# Access Audit Site Report

**Eisenhower State Park**  
**50 Park Rd 20**  
**Denison, TX 75020**  
**Accessibility Evaluation**  
**Inspection Date: 10/13/2021**  
**Inspectors: Tanya Scheibe**

**AMERICANS WITH DISABILITIES ACT COMPLIANCE INITIATIVE  
PROGRAM AND POLICY REPORT  
JULY 28, 2023**

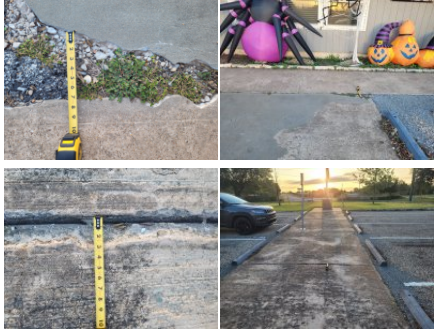
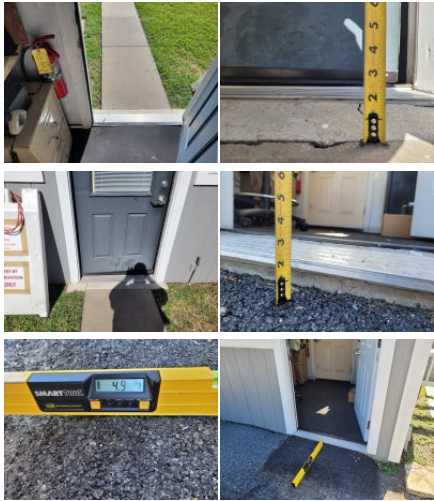
Finding Number	Area Description	Lat/Long	Finding	As Built	Recommendation	Citation	Photos	Figure
8	Headquarters: HQ Building	[33.8103569 , -96.599973 5]	Spaces and elements within employee work areas shall only be required to comply with 206.2.8, 207.1, and 215.3 and shall be designed and constructed so that individuals with disabilities can approach, enter, and exit the employee work area. Employee work areas, or portions of employee work areas, other than raised courtroom stations, that are less than 300 square feet (28 m2) and elevated 7 inches (180 mm) or more above the finish floor or ground where the elevation is essential to the function of the space shall not be required to comply with these requirements or to be on an accessible route.	Employee area entry - knob, 29" wide, wall on pull, offices have knobs (3), 1 has furniture in door clearance	For employee spaces, relocate storage, furniture, and other obstacles at doorways to provide approach, enter and exit at the employee space. Provide required maneuvering clearance on push and pull side of doors. Replace doors with doors having 80" overhead clearance and 32" clear width. Replace hardware with lever hardware or hardware operable without a tight pinch or grasp.	2015 ABAAS Section: F203.9  2012 TAS Section: 203.9  2010 ADAS Section: 203.9

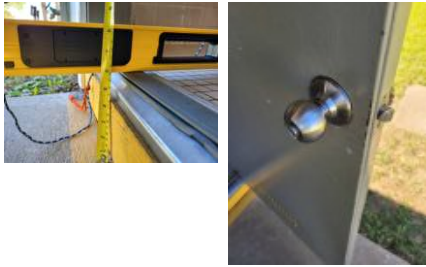
Finding Number	Area Description	Lat/Long	Finding	As Built	Recommendation	Citation	Photos	Figure
			<p>Projections into the clear opening width between 34 inches (865 mm) and 80 inches (2030 mm) above the finish floor or ground shall not exceed 4 inches (100 mm). The threshold has a vertical change greater than 1/4 inch high. The threshold at a doorway shall be no higher than 1/2 inch. Changes in level between 1/4 inch and 1/2 inch must be beveled at 1:2 or less. 1/4 inch is the maximum vertical rise. All interior doors must be maintained so that the operating pressure does not exceed 5 lb. force to open. The sweep period for doors with closers shall be adjusted so that from an open position of 70 degrees, the door will take at least 3 seconds to move to a point 3 inches from the latch, measured to the leading edge of the door. Exterior doors are recommended to be maintained at 8.5 lbf as a smart practice. Force is to be measured at the operating hardware or 30 inches from the hinges, whichever is greater. Hand-activated door opening hardware, handles, pulls, latches, locks, and other operating devices on accessible doors shall have a shape that is easy to grasp with one hand and does not require tight grasping, tight pinching or twisting of the wrist to operate. Hardware shall be 34 inches minimum and 48 inches maximum above the finish floor or ground. The bottom 10 inches on the push side must be smooth and free of obstructions (hold open devices). Opening hardware must be mounted between 30 and 44 inches above the floor or ground. Doors, gates, and side lights adjacent to doors or gates, containing one or more glazing panels that permit viewing through the panels shall have the bottom of at least one glazed panel located 43 inches (1090 mm) maximum above the finish floor.                      EXCEPTION: Vision lights with the lowest part more than 66 inches (1675 mm) from the finish floor or ground shall not be required to comply with 404.2.11.</p>

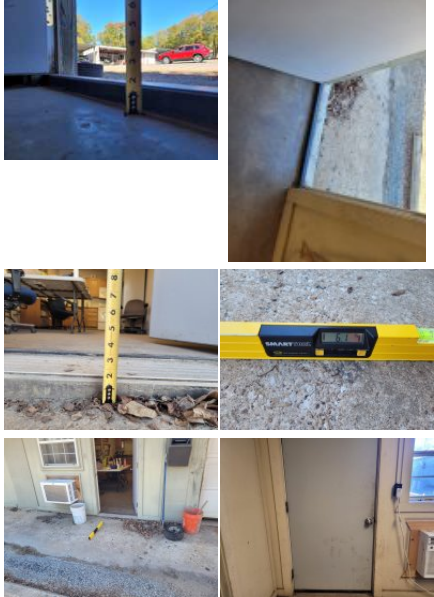
Finding Number	Area Description	Lat/Long	Finding	As Built	Recommendation	Citation	Photos	Figure
21	Headquarters: HQ Restrooms	[33.8103443 , -96.599952]	The restroom sign does not comply with one or more applicable requirements for the location, height, and properties of the sign.	Lacks raised lettering and Braille. Sign on pull side	Replace sign with one of contrasting colors that includes Braille, raised characters and mount on the wall, latch side of the door, 48" to the baseline of the lowest character and 60" to the baseline of the highest character	2015 ABAAS Section: F216.2, 703.1, 703.2, 703.5, 703.6  2012 TAS Section: 216.2, 703.1, 703.2, 703.5, 703.6  2010 ADAS Section: 216.2, 703.1, 703.2, 703.5, 703.6		
22	Headquarters: HQ Restrooms	[33.8103758 , -96.599970 8]	The threshold has a vertical change greater than 1/4 inch high. The sweep period for doors with closers shall be adjusted so that from an open position of 70 degrees, the door will take at least 3 seconds to move to a point 3 inches from the latch, measured to the leading edge of the door. Exterior doors are recommended to be maintained at 8.5 lbf as a smart practice. Force is to be measured at the operating hardware or 30 inches from the hinges, whichever is greater. Hand-activated door opening hardware, handles, pulls, latches, locks, and other operating devices on accessible doors shall have a shape that is easy to grasp with one hand and does not require tight grasping, tight pinching or twisting of the wrist to operate. Hardware shall be 34 inches minimum and 48 inches maximum above the finish floor or ground.	Restroom door - 6" threshold, knob, 9.5# push, fast close	For all doors along the public circulation route, repair, bevel, or ramp CILs at door entries to max .25". For all doors along the public circulation route, inspect, adjust, and maintain closing speed on door closers. For all doors along the public circulation route, inspect, adjust, and maintain 8.5 lbf to open exterior doors as a smart practice. For all doors along the public circulation route, replace hardware with lever hardware or hardware operable without a tight pinch or grasp.	2010 ADAS Section: 404.2.3, 404.2.7, 404.2.4, 404.2.11, 404.2.11 Exception

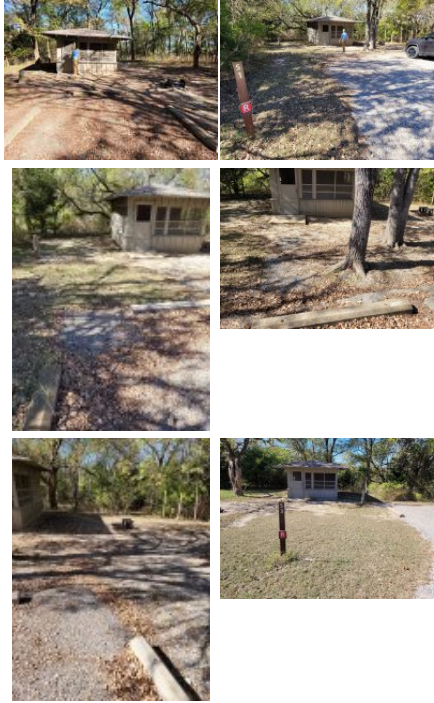
Finding Number	Area Description	Lat/Long	Finding	As Built	Recommendation	Citation	Photos	Figure
130	Deer Haven Camping Area: DH - Parking and Exterior Accessible Route	[33.8221714 , -96.610667 4]	There are no accessible parking stalls. Each lot where parking is provided for the public as clients, guests or employees, shall provide accessible parking and shall be located on the shortest accessible route of travel from adjacent parking to an accessible entrance. There are a total of 7 parking stalls in the parking lot that could be reasonably associated with this facility. There should be a minimum of 1 accessible stalls with a minimum of 1 being designed as van accessible.	Group Building Parking - 0 of 7 standard spaces	Create one or more 8' accessible parking stalls, with one 5' adjacent access aisle, with proper signage and striping based on the total number of stalls	2015 ABAAS Section: F208.2  2012 TAS Section: 208.2  2010 ADAS Section: 208.2

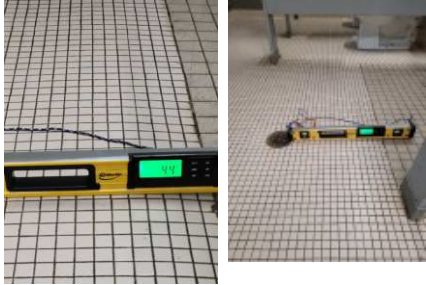
Finding Number	Area Description	Lat/Long	Finding	As Built	Recommendation	Citation	Photos	Figure
147	Deer Haven Camping Area: DH - Playground	[33.8230656 , -96.610686 2]	There is no accessible route to the elements. At least one accessible route shall connect accessible buildings, accessible facilities, accessible elements, and accessible spaces that are on the same site.	Lacks Accessible Route (AR) to swings (pea gravel surface), horseshoes, benches garbage and fire pit site.	Create an accessible route with crushed stone or other outdoor material from parking or walkway to the elements.	2015 ABAAS Section: F206.2.2  2012 TAS Section: 206.2.2  2010 ADAS Section: 206.2.2		
148	Deer Haven Camping Area: DH - Men's Restroom	[33.8227161 , -96.610986 6]	The restroom sign does not comply with one or more applicable requirements for the location, height, and properties of the sign.	Lacks raised characters and Braille	Replace sign with one of contrasting colors that includes Braille, raised characters, and the symbol of accessibility and mount on the wall, latch side of the door, 48" to the baseline of the lowest character and 60" to the baseline of the highest character	2015 ABAAS Section: F216.2, 703.1, 703.2, 703.5, 703.6  2012 TAS Section: 216.2, 703.1, 703.2, 703.5, 703.6  2010 ADAS Section: 216.2, 703.1, 703.2, 703.5, 703.6

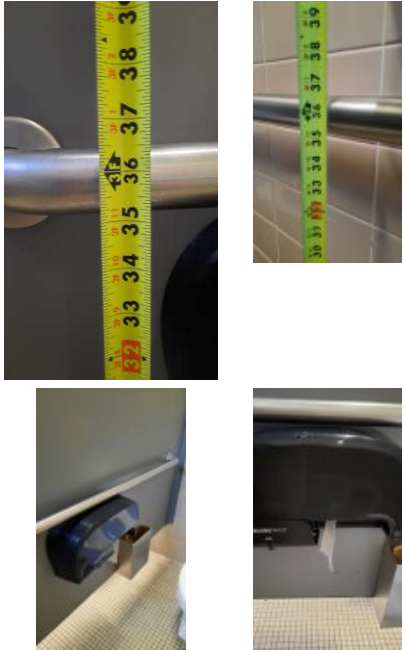
162	Deer Haven Camping Area: DH - Men's Restroom	[33.8227326 , -96.6110081]	There are no accessible bathing or shower facilities. Where facilities for bathing are provided for the public, clients or employees, including showers or bathtubs, at least one shower or bathtub and support facilities such as lockers, and not less than 1 percent of all facilities, shall be accessible.	lacks accessible shower	Create an accessible shower in locker/bathing room	2015 ABAAS Section: F213.3.6  2012 TAS Section: 213.3.6  2010 ADAS Section: 213.3.6

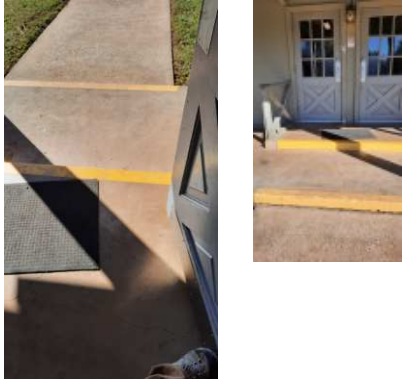
168	Deer Haven Camping Area: DH - Women's Restroom	[33.8227161 , -96.610997 3]	There are not enough accessible toilet compartments. The room contains toilet compartments. A minimum of 1 must be wheelchair accessible .	lacks wheelchair accessible stall, ambulatory only	Create a wheelchair accessible stall with grab bars and fixtures mounted in correct locations and at correct heights	2015 ABAAS Section: F213.3.1  2012 TAS Section: 213.3.1  2010 ADAS Section: 213.3.1

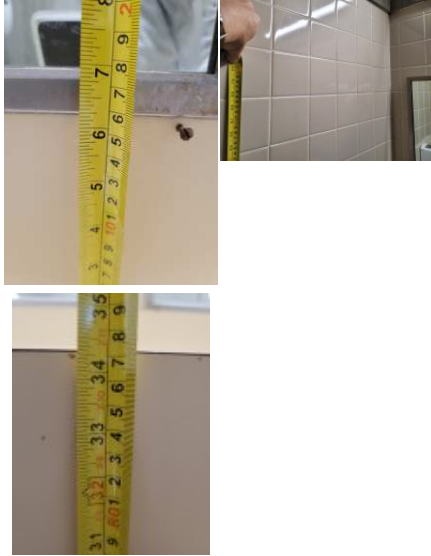
Finding Number	Area Description	Lat/Long	Finding	As Built	Recommendation	Citation	Photos	Figure
228	Fossil Ridge Camping Area: FR - Campsites	[33.8251589 , -96.616886 1]	Picnic tables shall provide at least one wheelchair space for each 24 linear feet (7320 mm) of usable table surface perimeter. Wheelchair spaces shall be 30 inches (760 mm) minimum by 48 inches (1220 mm) minimum. Wheelchair spaces shall be positioned for a forward approach to the table and provide knee and toe clearance complying with 306 under the table	Site 144 - lacks accessible table	Replace picnic table with one of an accessible design as a smart practice.	2015 ABAAS Section: 1011.4.2		
229	Fossil Ridge Camping Area: FR - Campsites	[33.8251375 , -96.616874 1]	Picnic tables are required to have clear ground space 36 inches (915 mm) on all usable sides of the table measured from the back edge of the benches.	Site 144 - Less than 30" all around	Provide required 36" clear ground space around all usable portions of the table as a smart practice.	2015 ABAAS Section: 1011.2.1

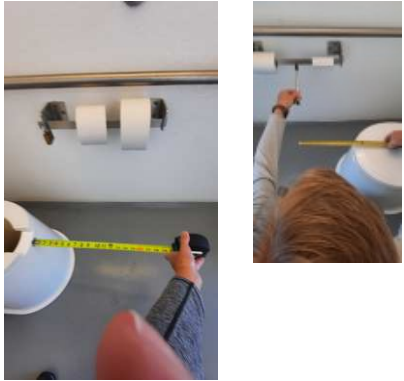
266	Fossil Ridge Camping Area: FR - Women's Restroom	[33.824843, -96.6166756]	The accessible route contains running slopes greater than 5 percent and cross slopes greater than 2 percent across the width of the walk and has not been constructed as a ramp (i.e. handrails, wheel guides, etc.). When the slope in the direction of travel of any walk exceeds 1 unit vertical in 20 units horizontal (5-percent slope), it must be constructed as ramp. Surface cross slopes must not exceed one unit vertical in 48 units. Horizontal (2-percent slope).	4.7% slope at drain	Correct or repair slope to max 5% running and 2.08% cross	2015 ABAAS Section: 403.3 2012 TAS Section: 403.3 2010 ADAS Section: 403.3

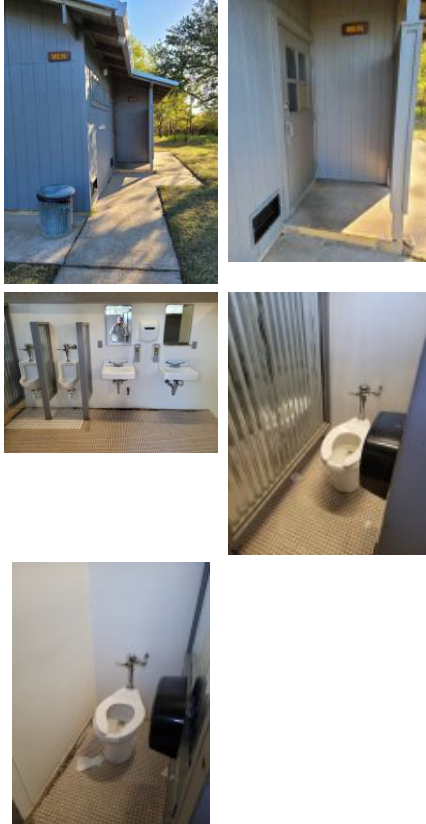
Finding Number	Area Description	Lat/Long	Finding	As Built	Recommendation	Citation	Photos	Figure
294	Elm Point Camping Area: EP - Campsites	[33.8284512 , -96.620255]	The surface of parking spaces and pull-up spaces shall be firm and stable. The slope of the surface of parking spaces and pull-up spaces shall not be steeper than 1:48 in any direction. EXCEPTION: Where the surface is other than asphalt, concrete, or boards, slopes not steeper than 1:20 shall be permitted when necessary for drainage.	Site 169 - Loose gravel, 5.8% slope	Correct surface of parking spaces to be firm and stable with slopes max of 2.08% or 5% for surfaces other than concrete, asphalt or boards as a smart practice.	2015 ABAAS Section: 1012.4, 1012.5, 1012.5 EXCEPTION		
295	Elm Point Camping Area: EP - Campsites	[33.8284518 , -96.6202671]	A clear floor space at the tent pad and/or tent platform is not provided. Clear ground space shall be provided on all usable sides of tent pads and tent platforms. The clear ground space shall be 48 inches wide minimum. The surface of the clear ground space shall be firm and stable. The surface shall allow use of tent stakes and other tent securement devices. The slope of the surface of tent pads, tent platforms, and clear ground spaces shall not be steeper than 1:48 in any direction. Where the surface is other than asphalt, concrete, or boards, slopes not steeper than 1:20 shall be permitted where necessary for drainage.	Site 169 - Dirt surface	Replace existing surface around tent platform with an accessible surface such as EWF, boardwalk, crushed stone, or asphalt with compliant slopes and CILs	2015 ABAAS Section: 1013.2

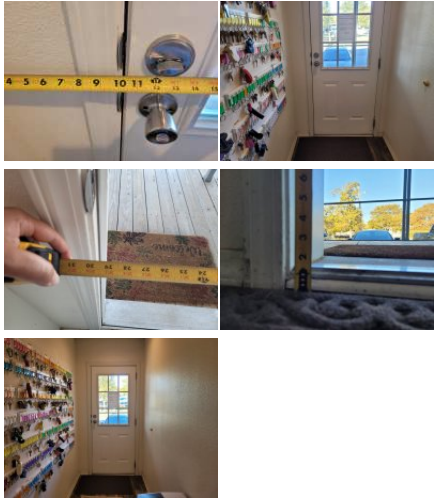
Finding Number	Area Description	Lat/Long	Finding	As Built	Recommendation	Citation	Photos	Figure
303	Elm Point Camping Area: EP - Men's Restroom	[33.826973, -96.618735]	This restroom is not accessible. Where existing toilet rooms or bathing rooms do not comply, directional signs indicating the location of the nearest accessible toilet room or bathing room within the facility shall be provided. Signs shall include the International Symbol of Accessibility. Where existing toilet rooms or bathing rooms do comply), the accessible toilet rooms or bathing rooms shall be identified by the International Symbol of Where clustered single user toilet rooms or bathing facilities are permitted, accessible toilet rooms or bathing facilities shall be identified by the International Symbol of Accessibility unless all toilet rooms and bathing facilities are accessible.	Lacks accessible features	Restroom not accessible, acquire and mount signage directing patrons to accessible restroom until renovations occur.	2015 ABAAS Section: F216.8 2012 TAS Section: 216.8 2010 ADAS Section: 216.8

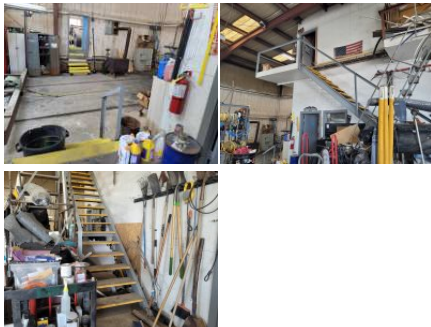
353	Eisenhower Yacht Club: Yacht Club- Shop	[33.820336, -96.6078323]	Spaces and elements within employee work areas shall only be required to comply with 206.2.8, 207.1, and 215.3 and shall be designed and constructed so that individuals with disabilities can approach, enter, and exit the employee work area. Employee work areas, or portions of employee work areas, other than raised courtroom stations, that are less than 300 square feet (28 m2) and elevated 7 inches (180 mm) or more above the finish floor or ground where the elevation is essential to the function of the space shall not be required to comply with these requirements or to be on an accessible route.	Parts - File cabinet pull side, knob	For employee spaces, relocate storage, furniture, and other obstacles at doorways to provide approach, enter and exit at the employee space. Provide required maneuvering clearance on push and pull side of doors. Replace hardware with lever hardware or hardware operable without a tight pinch or grasp.	2015 ABAAS Section: F203.9  2012 TAS Section: 203.9  2010 ADAS Section: 203.9

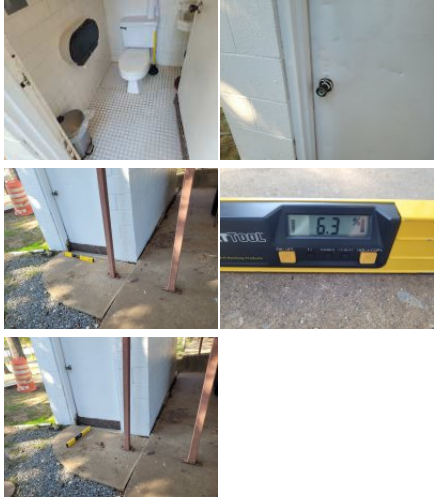
361	Eisenhower Yacht Club: Yacht Club- Shop	[33.8203897 , -96.607835]	There is no accessible route between elements in the building. An accessible route of travel must connect all elements and spaces within a building or facility.	Stairs between areas, noncompliance stairs to upper level	No AR to employee area, leave as is, and reassign duties if an employee with disabilities requires access here.	2015 ABAAS Section: F206.2.4  2012 TAS Section: 206.2.4  2010 ADAS Section: 206.2.4
